# SERVICE BULLETIN

**Service Bulletin No.:** DA20-72-04 Rev 0

**Title:** Change of measurement from CHT to Coolant Temperature

**Figure 1: Coolant Temperature Indicator**

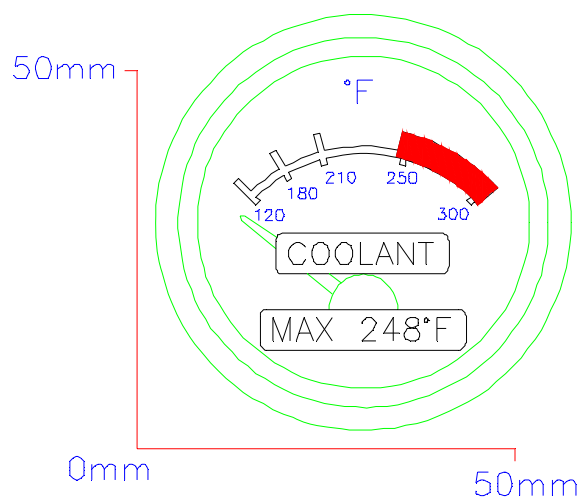
- 10.1 Install cylinder head temperature probe (p/n 965531) onto cylinder #3 in accordance with Rotax service instruction SI-912-020 Section 72-00-00, latest approved revision.
- a. If necessary, secure excess slack of temperature wire harness to itself using cable tie p/n MS3367-5-9, or equivalent.
- 10.2 Fill engine with suitable coolant in accordance with Rotax Service Instruction SI-912-016, latest approved revision. If adding Evans NPG+ coolant, then refer to service bulletin DA20-72-02.
- 10.3 If service bulletin DA20-72-03L has previously been performed, then remove associated MAX CHT placard, and optionally remove associated temperature indication light on the instrument panel.
- 10.4 Label the cylinder head temperature (CHT) indicator with "COOLANT MAX 248°F" using a permanent label directly on the face of the indicator. Reference Figure 1.

- 10.5 Mark the Coolant Temperature indicator as follows:
- Cut out the full scale template (Figure 1).
  - Place template on the face of the Coolant Temperature indicator to define a radial line at 248°F (120°C) and, an arc from 248°F (120°C) to 302°F (150 °C).
  - Mask and carefully etch surface.
  - Wipe clean.
  - Apply Testors acrylic red paint or equivalent.
  - Allow to dry.
  - Inspect and ensure area is properly marked from 248°F (120°C).
